## Project #16-044 Milk Money Trucking Located at 1180 West 600 North

**REPORT SUMMARY...**

Project Name: Milk Money Trucking

Project Address: 1180 West 600 North
Request: Design Review Permit

L-101

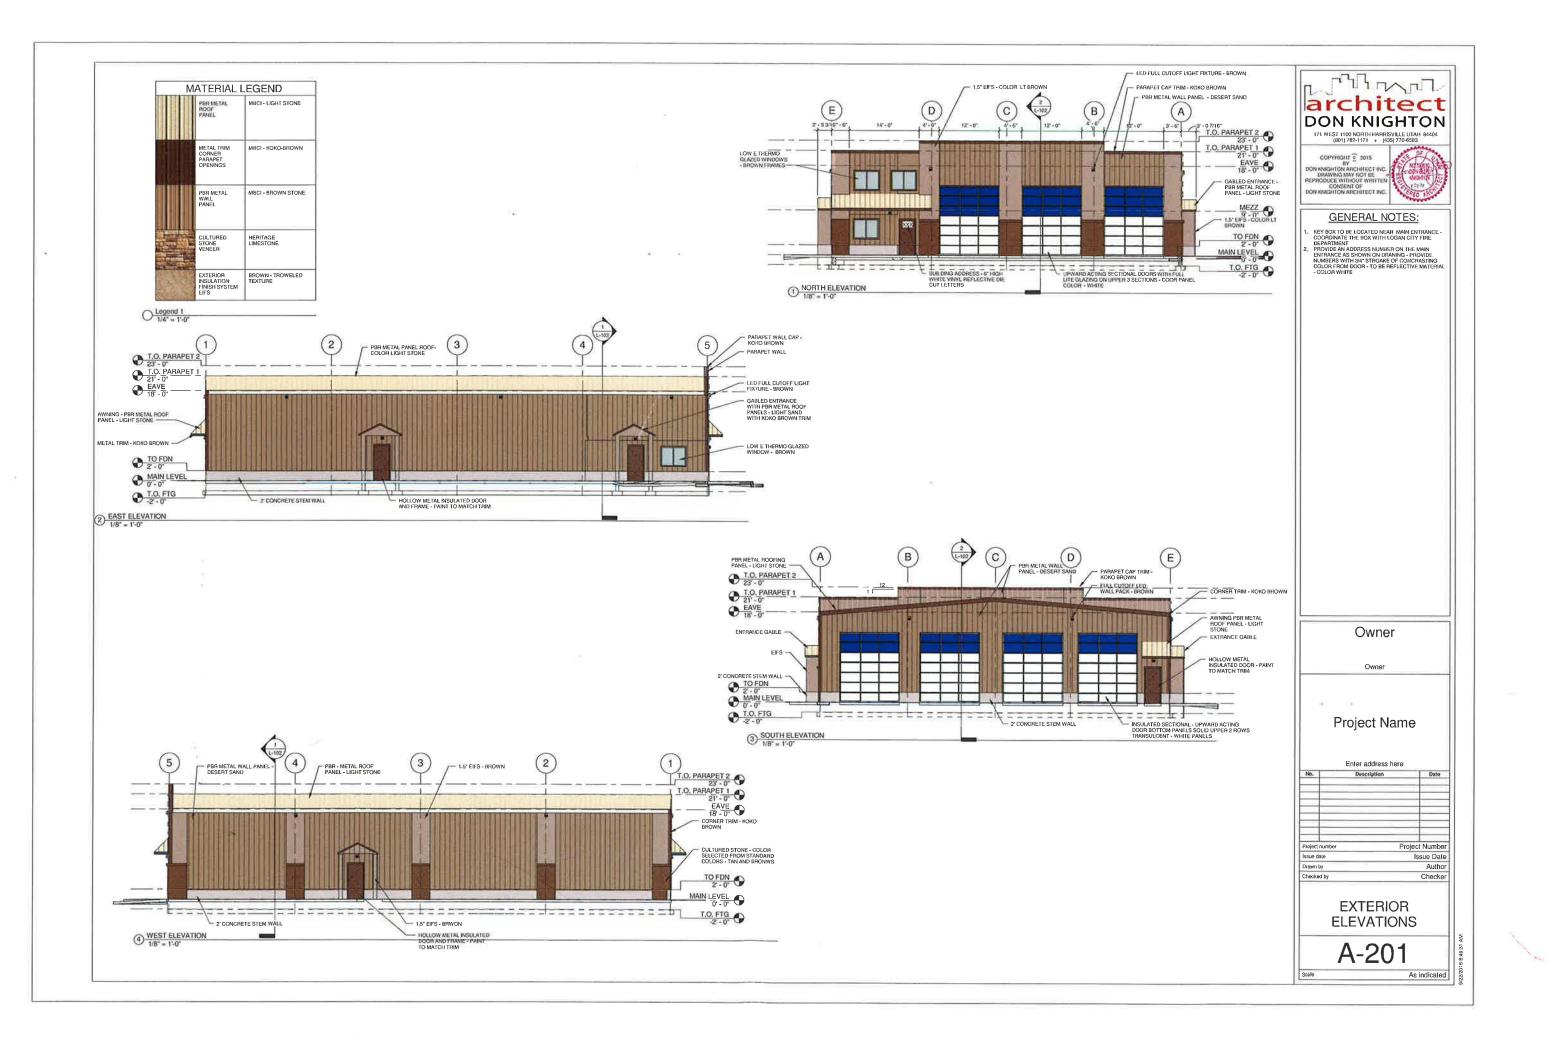
The LDC 17.39 requires minimum plant material for overall visual aesthetics, ecological reasons, screening, and shading purposes. The LDC requires a minimum of 20 trees and a combination of 50 shrubs, flowers and ornamental grasses per acre of land in the CS zone. For 0.90 acres, 18 trees and 45 shrubs, flowers and ornamental plants would be required as per the LDC. The proposed plan shows 30 trees and 47 shrubs, perennials and grasses meeting the requirements of the LDC.

- 3. The landscaping and open space shall comply with the LDC and match the submitted landscaping plan. The plan shall include the following:
  - a) Street trees along all adjacent streets provided every thirty (30) feet on center.

- b) Open Space and Useable Outdoor areas shall total a minimum of 7.840 SF.
  - c) A total number 18 trees and 45 shrubs, perennials and grasses shall be provided.

- d) The landscaping area between the parking lot and 600 North shall consist of dense shrubs as per type "B" standards (LDC 17.39.070).
- 4. The dumpsters shall be visually screened or buffered from 600 North street by using landscaping shrubs and bushes or fences/walls (fences and walls are limited to 4' tall in front yard)
